# Technical Memo

Project: Durham York Energy Centre (DYEC)

From: Bruce Howie, PE, HDR Corporation (HDR)  
John Clark, PE (HDR)

Subject: **Covanta Phase 1 Completion and Recommendation for Boiler #1 Restart**

Figure 1

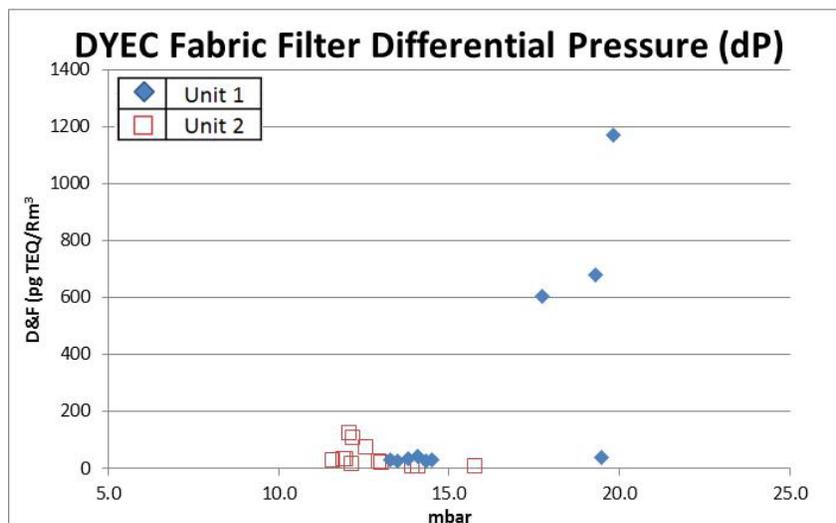
HDR is also in agreement that the high fly ash buildup in the 2<sup>nd</sup>/3<sup>rd</sup> pass hopper and the baghouse issues are two of the most probable causes of the high emissions of D&F. A graph of the fabric filter differential pressure (dP) data from all D&F testing to date is shown in Figure 1. As seen in the graph, the higher D&F results were measured when the fabric filter dP was at the highest. There are many factors associated with this variable and this graph alone is not intended to show a direct correlation.

Photo 4 - IGR Nozzles – Boiler Sidewalls

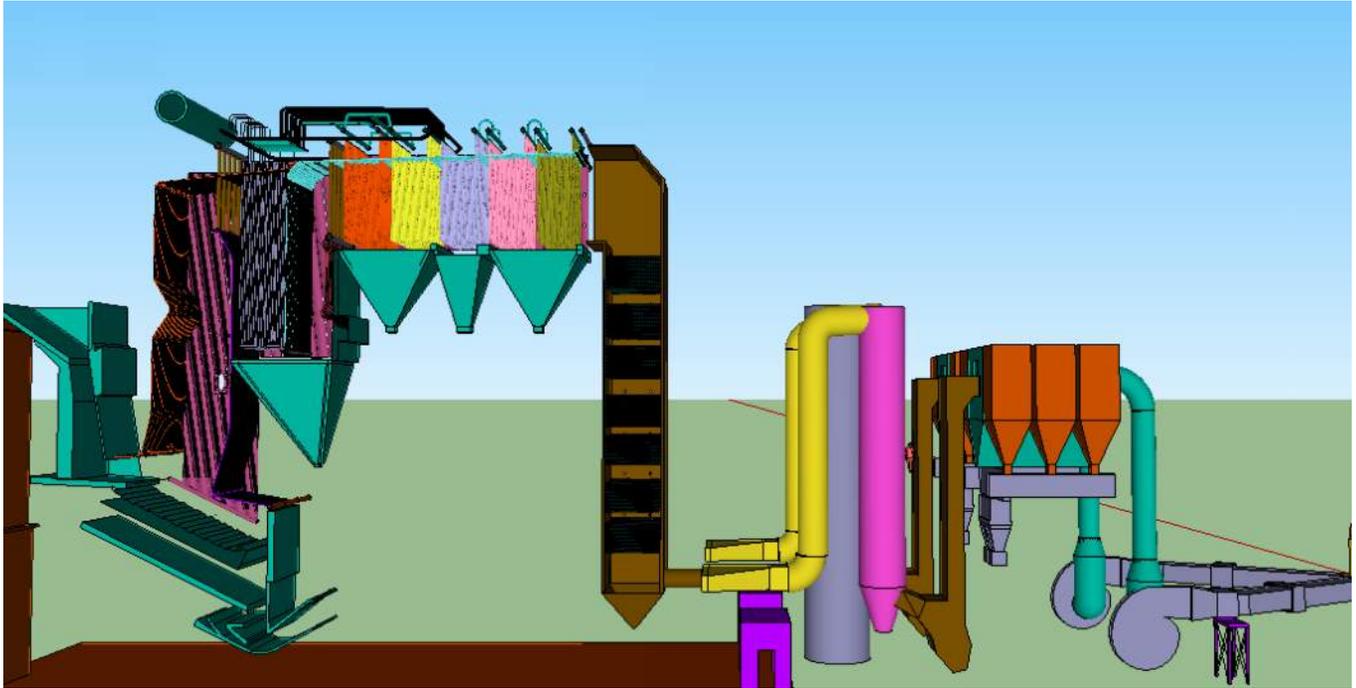
- Two (2) of the ten (10) NO<sub>x</sub> Reduction System Internal Gas Recirculation (IGR) nozzles on the right side of boiler #1 were plugged (see Photos 4, 5 and 6 in Attachment 3). These nozzles are alternating sizes of 40 mm and 55 mm. Boiler #2 nozzles are 40 mm and 70 mm. There may be some slight impact of the plugged nozzles on carbon monoxide (CO) or combustion control with the two (2) configurations. Covanta's Corporate engineers are planning to monitor composition of the IGR gases during Phase 2. HDR will continue to review and monitor these activities.

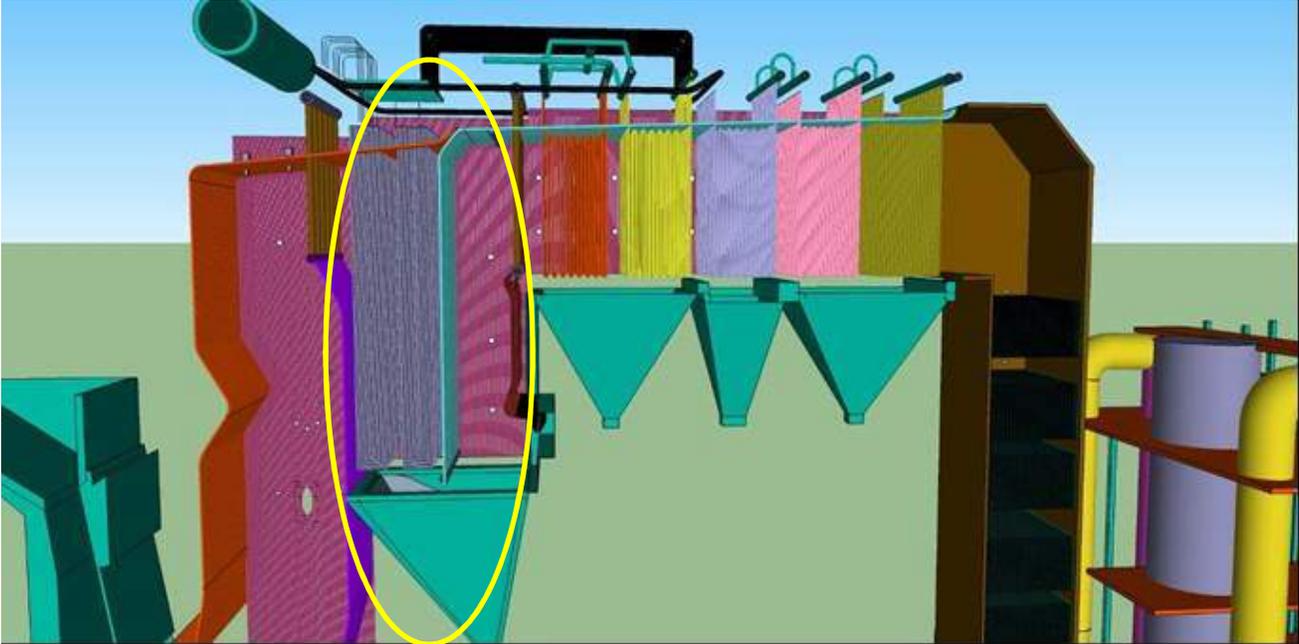
- Buildup on the boiler #1 tubes appeared typical of other similar boilers based on the current point in the operating campaign. Therefore, this buildup does not appear to be a contributor to the D&F exceedance in boiler #1. No staging or access into the boiler was provided, so HDR performed all inspections externally. (see Photos 7 through 12 and Photos 14 through 18 in Attachment 3)

Photo 18 - Economizer Sootblowers 122 and 123 – Lances Repaired but Steam Remain Locked Out  
HDR to monitor during startup)

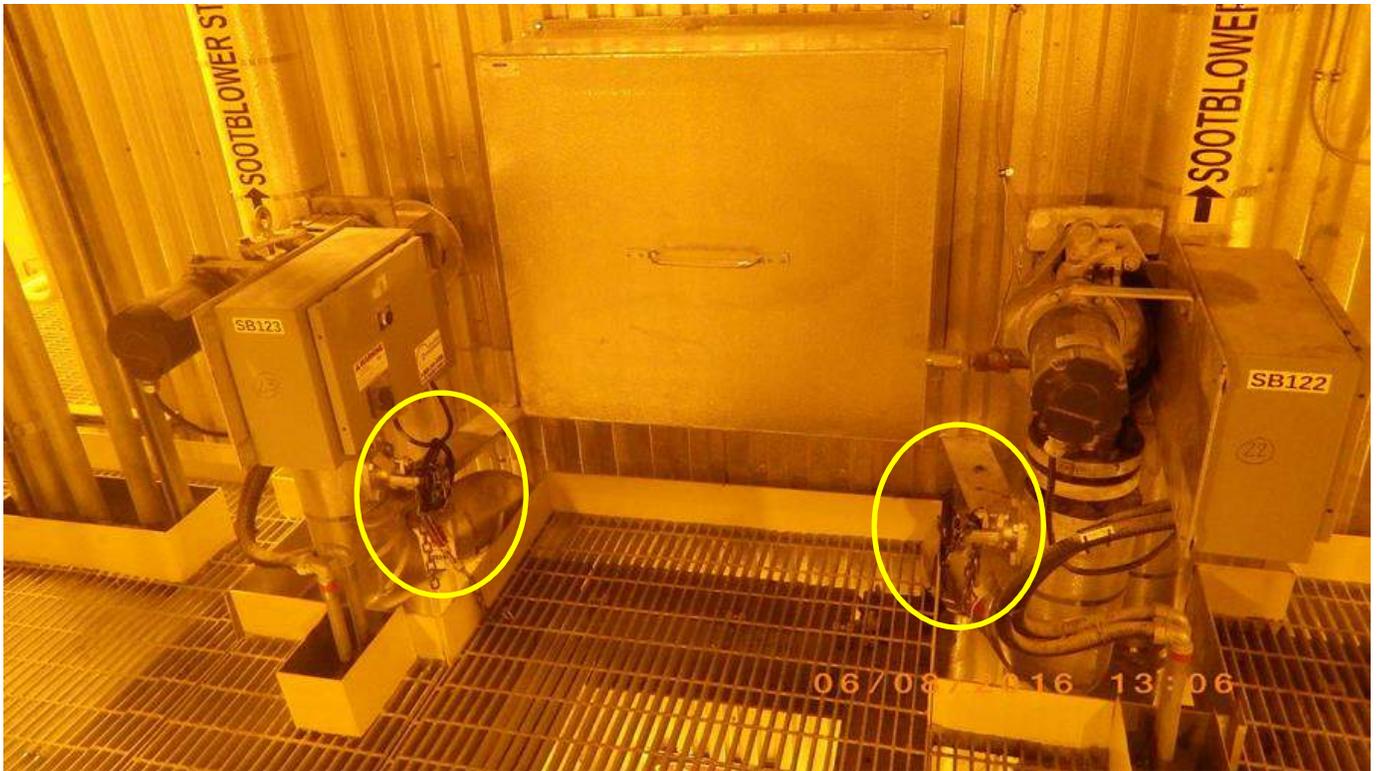
- Economizer sootblowers 122 and 123 were found to have broken lances. This would render the sootblowers ineffective in this area and could cause damage to tubes. While it is possible that blowing uncontrolled steam into this section could have an impact on emissions, it would not be expected to be significant. The lances have been repaired. Currently the steam is isolated to these sootblowers (see Photo 18 in Attachment 3). HDR will monitor the full sootblowing sequence with Covanta during startup of boiler #1.

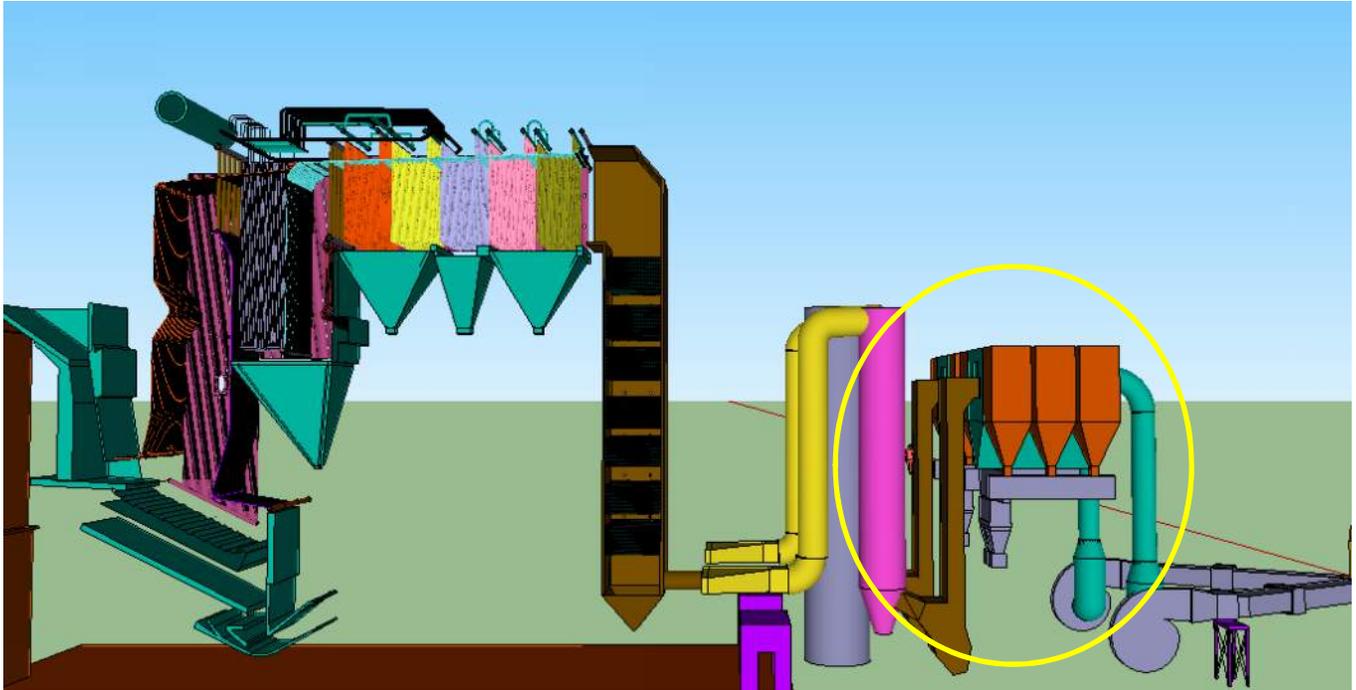
- a. There were numerous bags that were bridged and plugged and may have contributed to degraded baghouse performance. (See Photos 19 through 26 in Attachment 3) Approximately 93 filter bags were replaced by Covanta during the outage (out of a total of 1560 bags). Only one bag was found to have a small hole, and the remaining 92 bags were replaced as a precautionary measure. A Visolite test (a tracer method that uses a fluorescent powder and a blacklight to detect bag leaks) was performed to verify that no other bag leaks were present.

Photo 39 - Close up view of Inlet To Baghouse Inlet Duct – 2<sup>nd</sup> Row of Baffle Screens Remained Partially Plugged (as left)

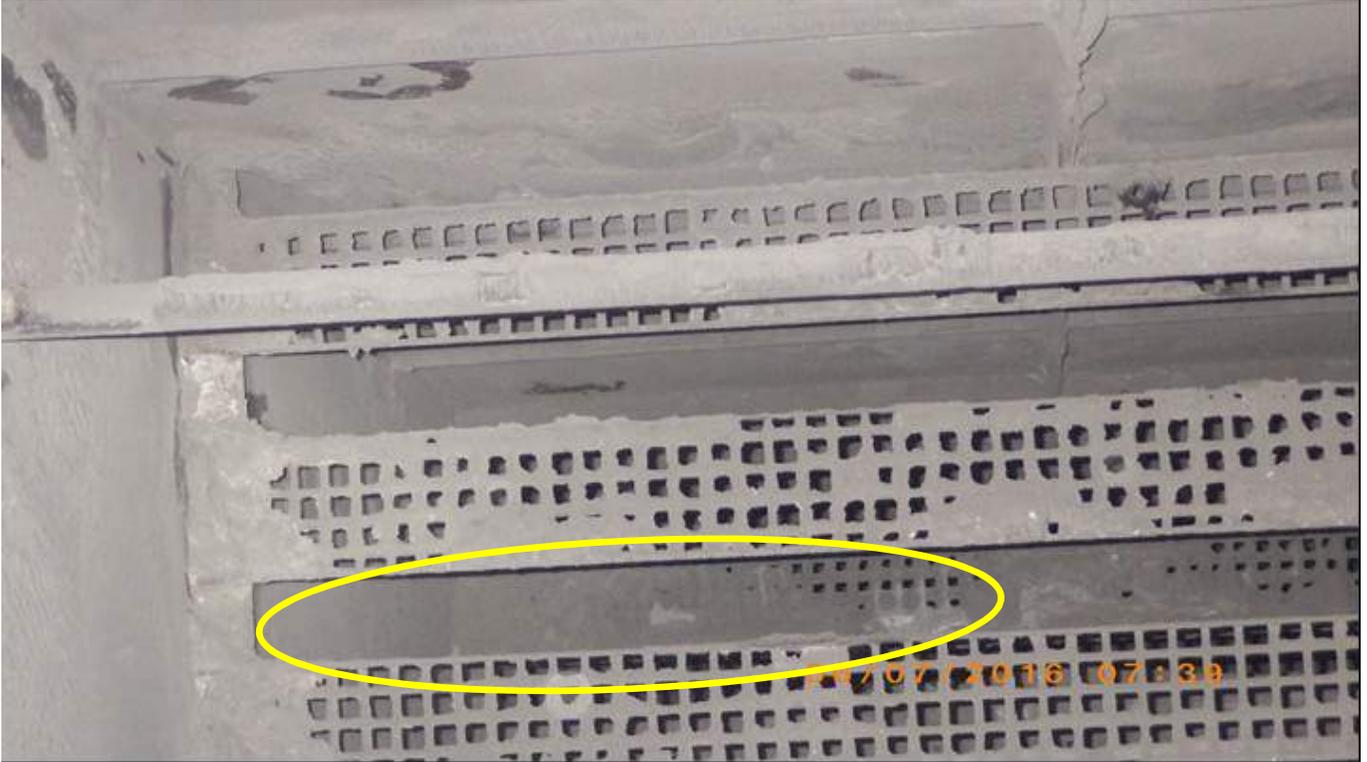
- b. Inspection of the on-line boiler #2 revealed some similar baghouse bag plugging, but to a significantly lesser degree. (See Photo 45 in Attachment 3)
- c. The dispersion plates (screened plates) in the inlet duct to the baghouse had become heavily fouled and plugged, altering the distribution of flue gas and flyash concentrations to the various baghouse compartments. (See Photos 37, 38 and 39 in Attachment 3)

- The inlet duct to the baghouse had heavy deposits of fly ash on the distribution baffle plates. These were cleaned off with the exception of the extreme left and right sides of the second row of baffles (see Photos 37, 38, and 39 in Attachment 3). An uneven distribution of particulate and PAC to the six (6) baghouse compartments could adversely impact the baghouse removal efficiency.
